ECE/TRANS/WP.29/GRRF/2002/17/Rev.7
23 November 2006

REVISED PROPOSAL FOR DRAFT AMENDMENTS TO REGULATION No. 64
(Temporary use spare wheels/tyres)

Submitted by the expert from the United Kingdom

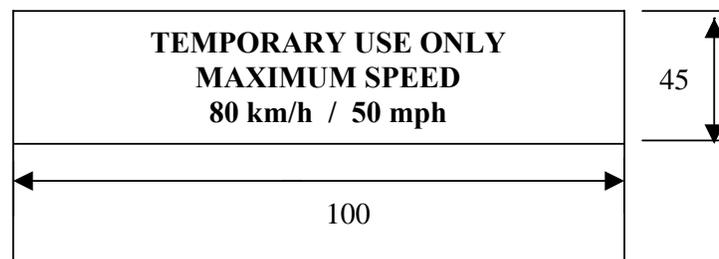
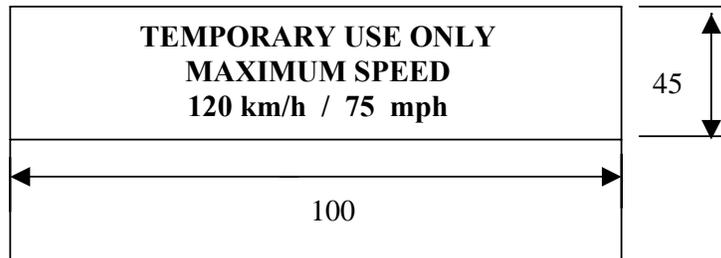
Paragraph 5.1.4.1., amend to read (the diagram is not amended):

"5.1.4.1. An 80 km/h maximum speed warning symbol arranged in accordance with the diagram below shall be permanently displayed on the outer face of the wheel in a prominent position.

In the case of vehicles intended to be sold in countries using imperial units of measurement, an additional warning symbol, identical to that described above, with the exception that the figure "80" shall be replaced by "50" and the wording "km/h" by "mph", shall be permanently displayed on the outer face of the wheel in a prominent position.

Alternatively a single warning symbol arranged in accordance with the diagram below, shall be permanently displayed on the outer face of the wheel in a prominent position.

Upper case letters shall be at least 5 mm high and the numbers "80" and "50" shall be at least 20 mm high with the elements that make up each character of the number at least 3 mm line thickness. Lower case text shall at least have a line height of 5 mm. All text shall be enclosed in a border and be on a background of contrasting colour.

The requirements of this paragraph shall only apply to types 1, 2 and 3 temporary use spare unit as defined in paragraphs 2.10.1., 2.10.2. and 2.10.3."
